RENAUD BROS., INC.

Wardsboro BRF 013-1 (15)

Conceptual Value Engineering Proposal

DECK TYPICAL
 SCALE 1/2" = 1'-0"

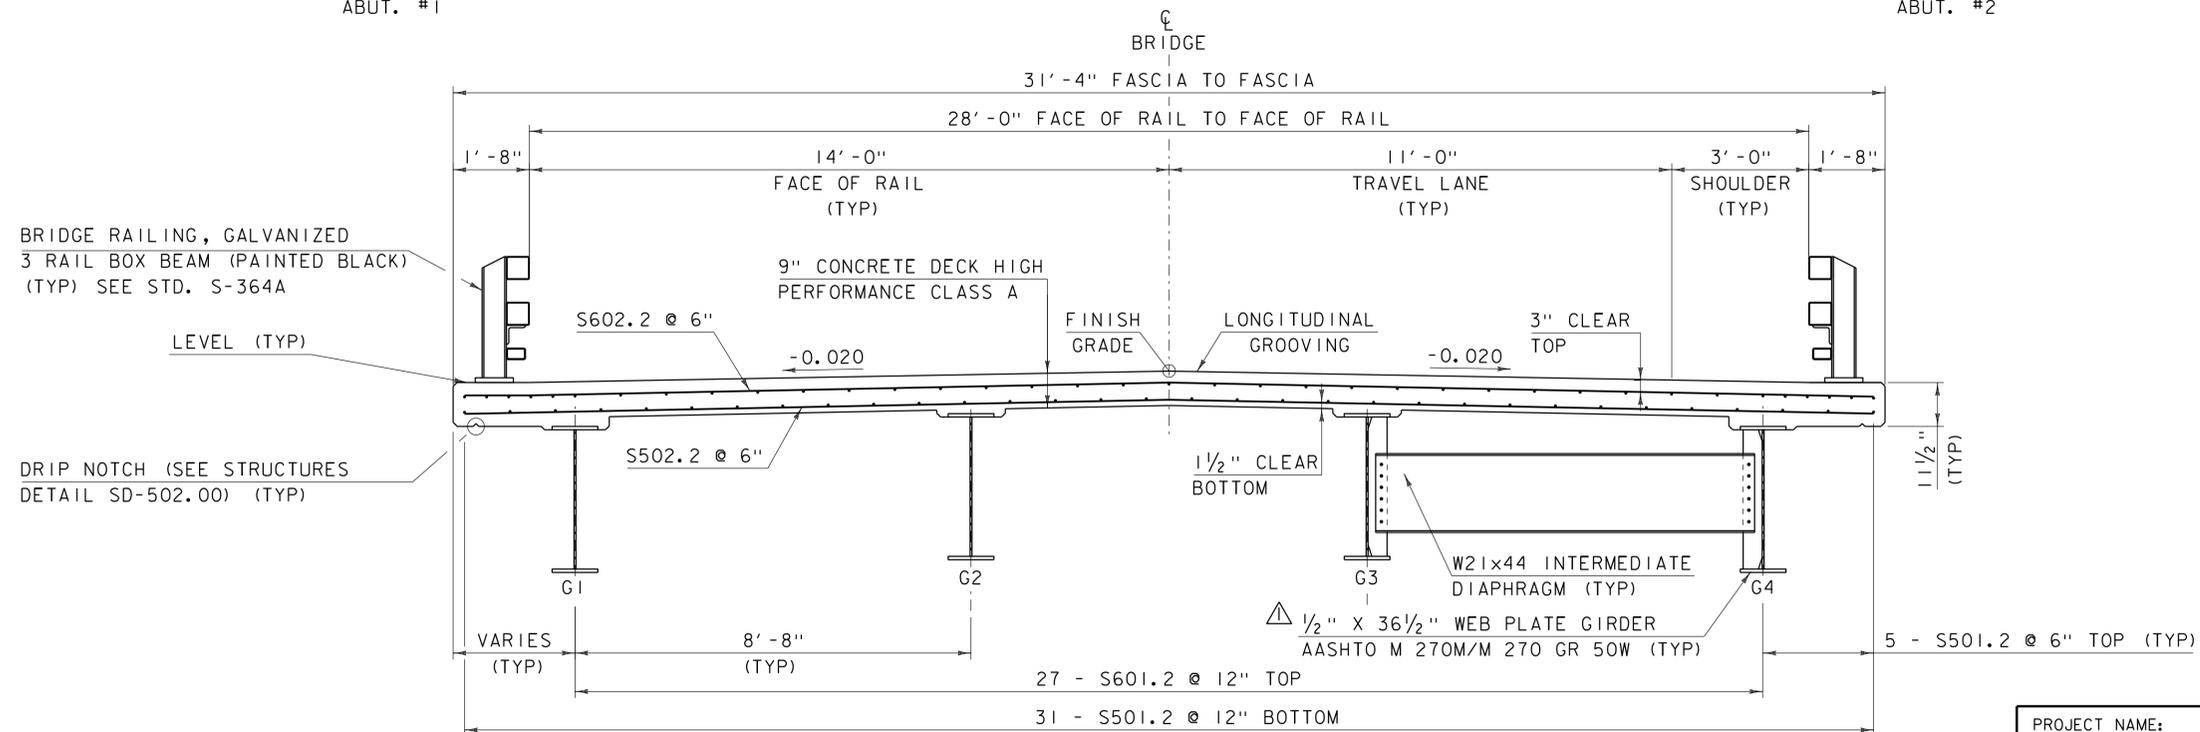
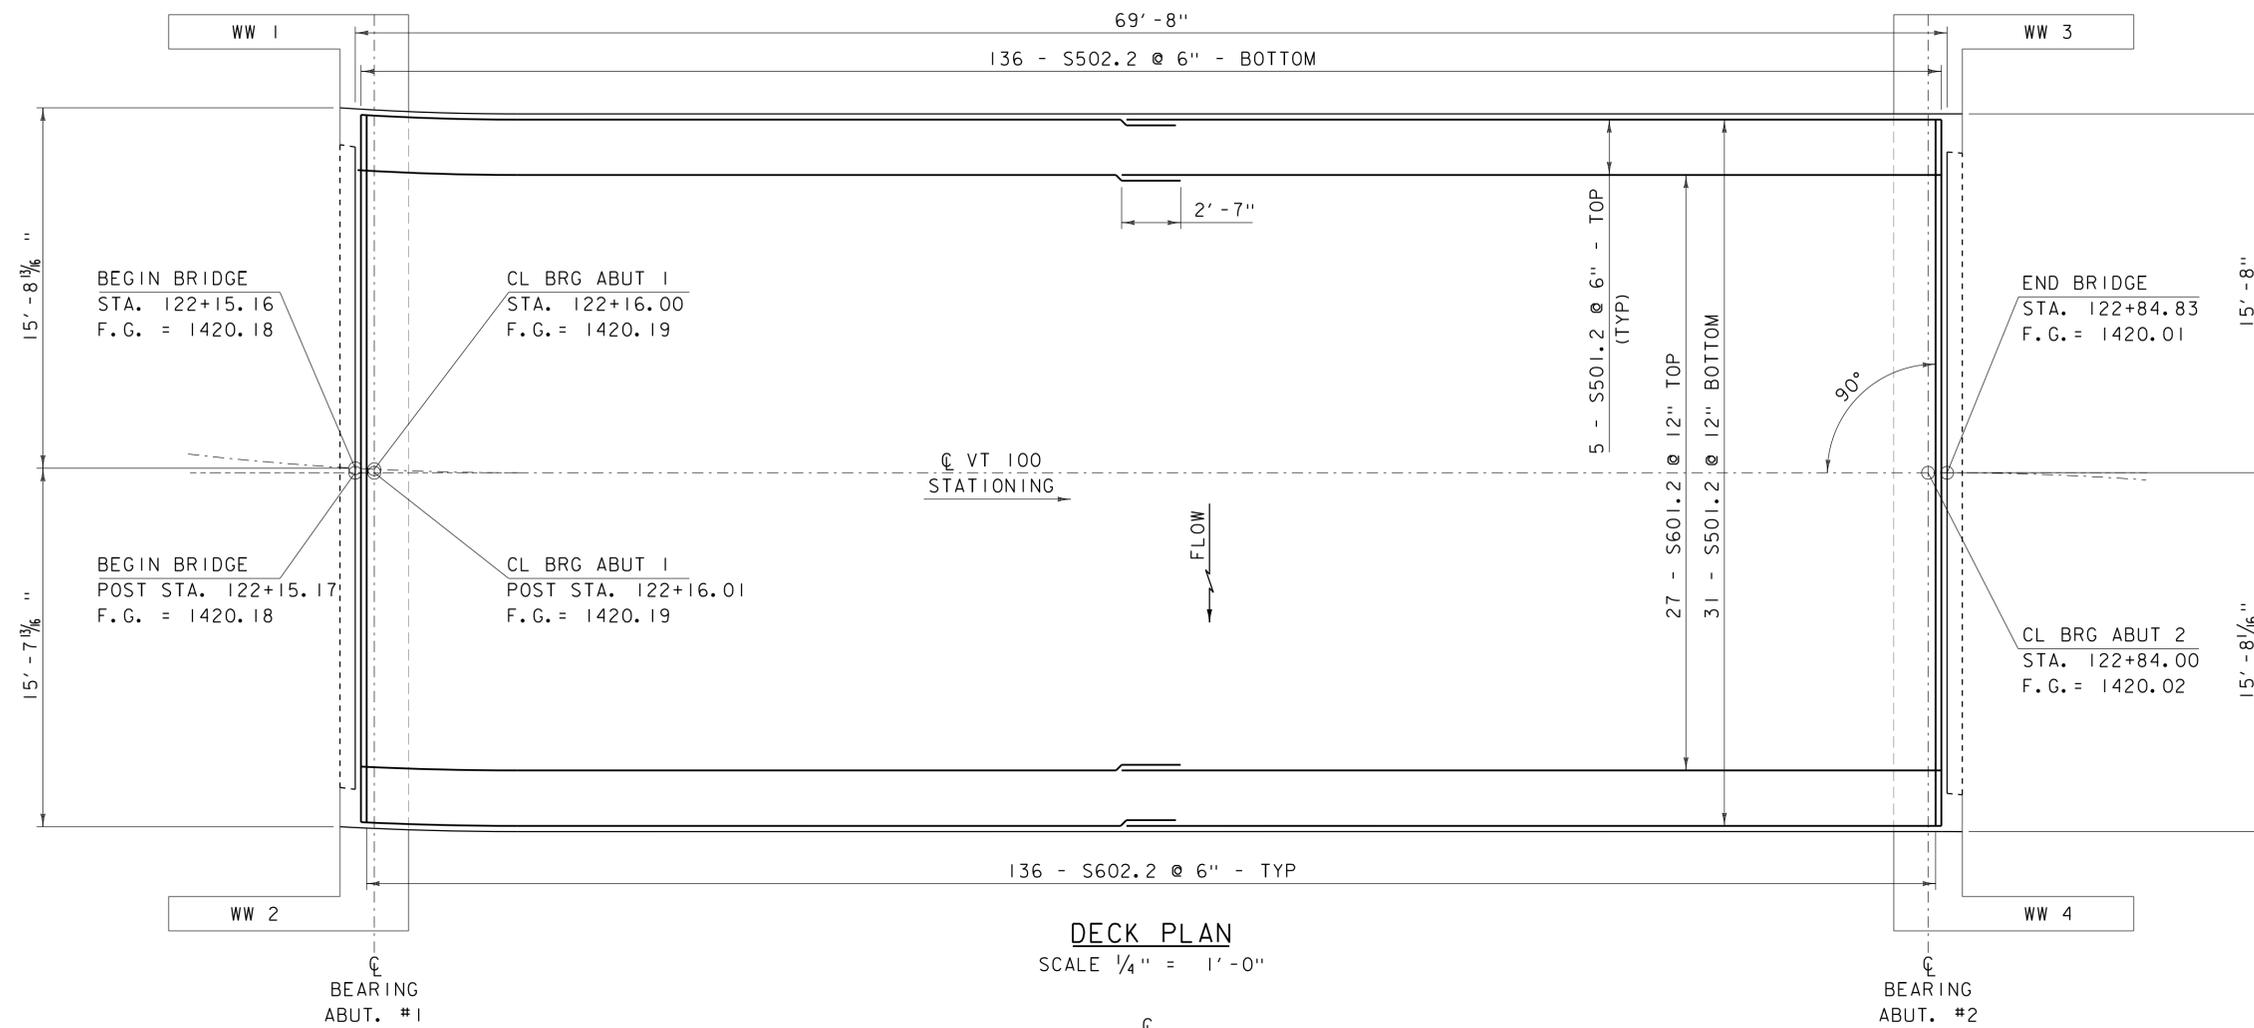
KEY	DATE	BY	REVISION
▲	10/05/2015	VAOT	MODIFIED ROLLED BEAM TO PLATE GIRDER.

TYPICAL GIRDER ELEVATION △
SCALE 1/4" = 1'-0"

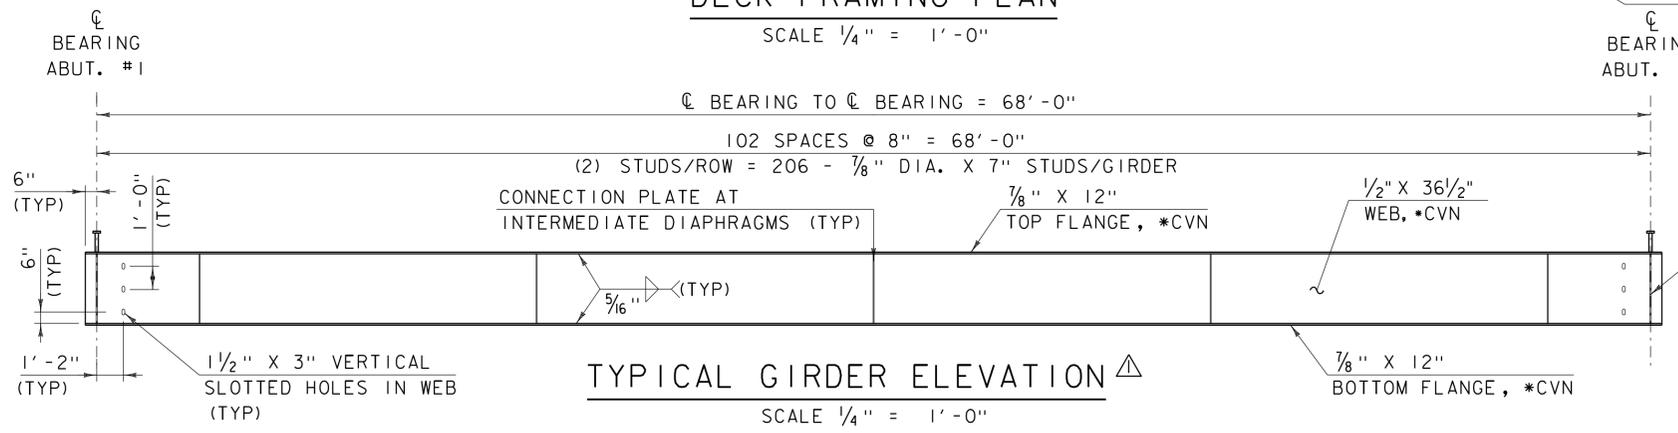
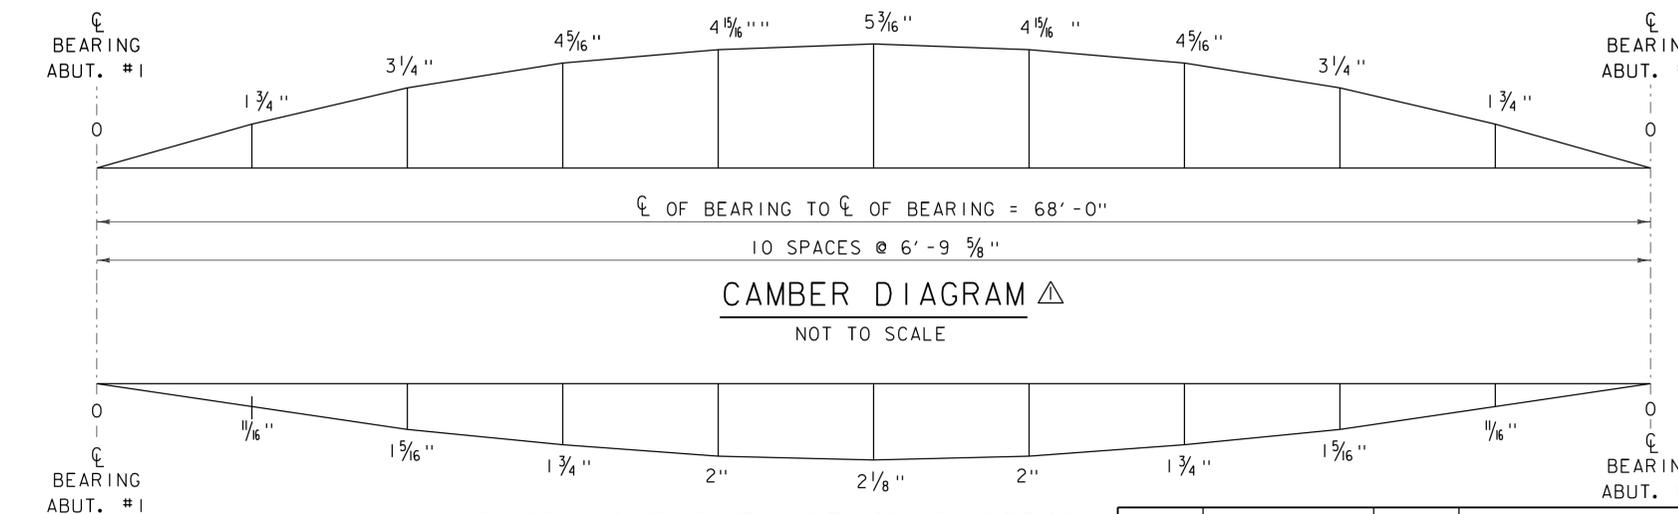
This CVEP is to use built-up welded plate girders in lieu of the W40 x 149 Rolled Beams. We will utilize 1/2" webs, 7/8" flanges and 5/16" fillet welds as shown on the revised contract sheet 26.

KEY	DATE	BY	REVISION
△	10/05/2015	VAOT	MODIFIED ROLLED BEAM TO PLATE GIRDER.

BEARING STIFFENER
3/4" x 5" PLATE EACH
SIDE OF GIRDER
AT CL OF BEARING (TYP)
SEE SD-602.00 FOR
CONNECTION DETAILS

△ NOTE:
*CVN - SHALL MEET CHARPY V-NOTCH REQUIREMENTS
FOR MAIN MEMBERS AS INDICATED IN SECTION 714
OF THE STANDARD SPECIFICATION.
DEAD LOAD DEFLECTION INCLUDES: GIRDER, DIAPHRAGMS,
DECK & BRIDGE RAIL.

INTEGRAL ABUTMENT NO. 1 ELEVATION

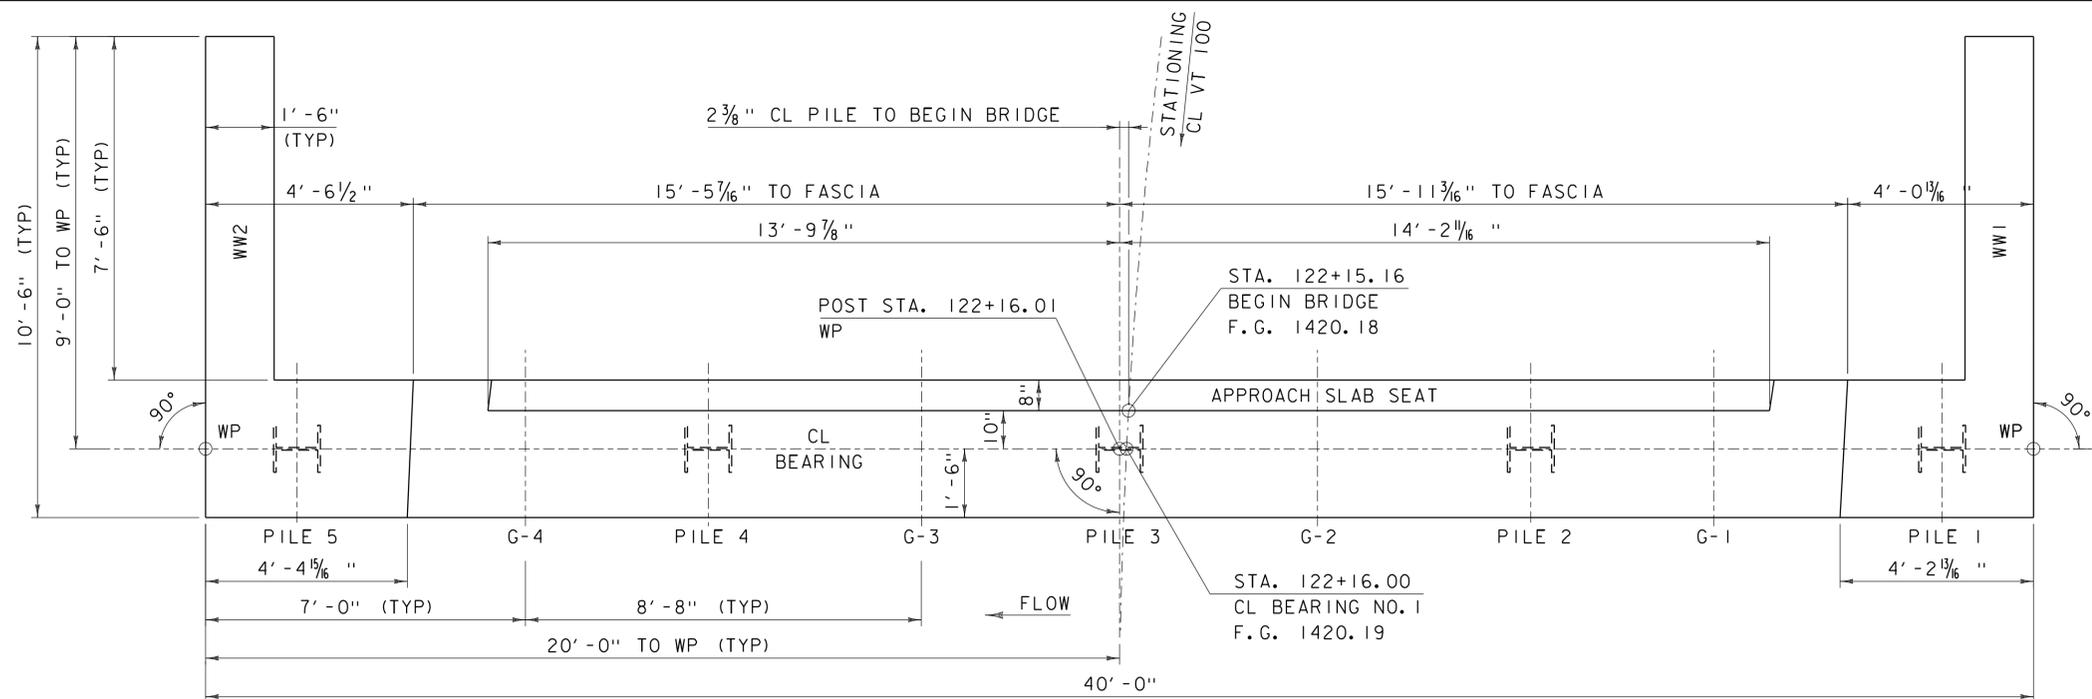
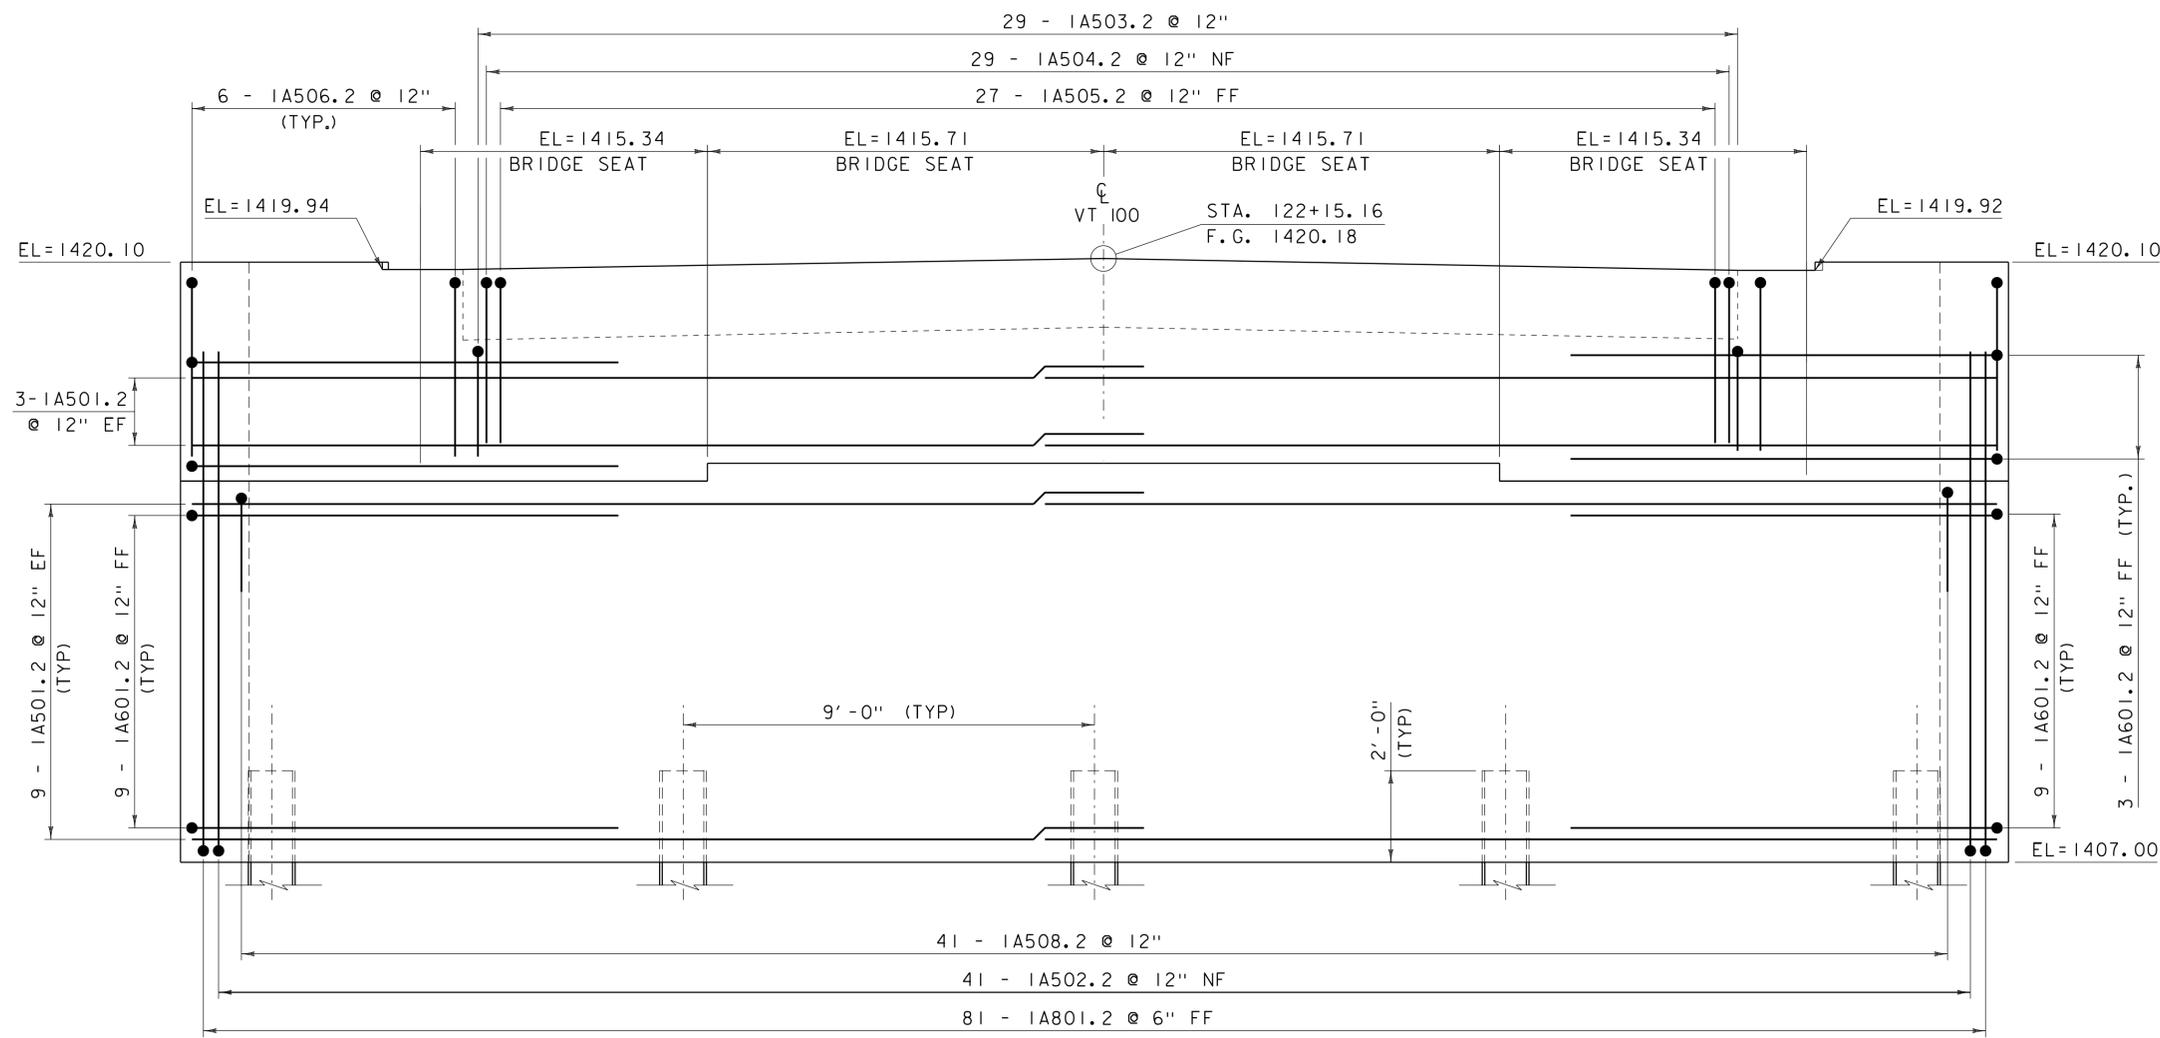
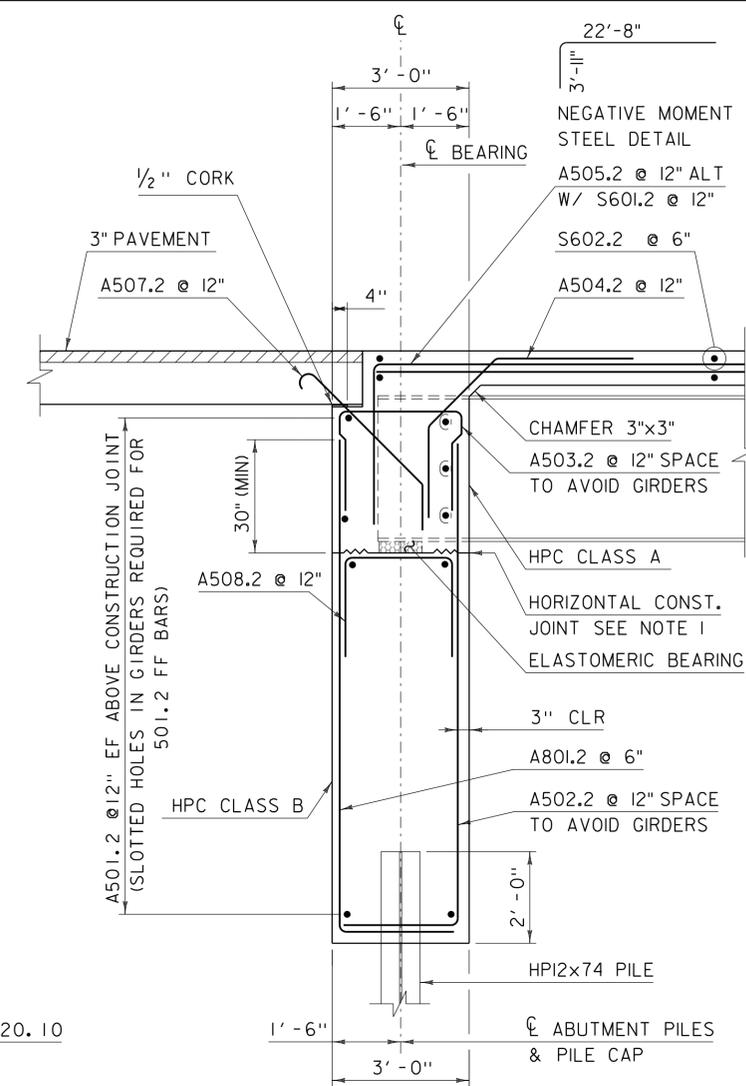
KEY	DATE	BY	REVISION
▲	10/05/2015	VAOT	MODIFIED ROLLED BEAM TO PLATE GIRDER.
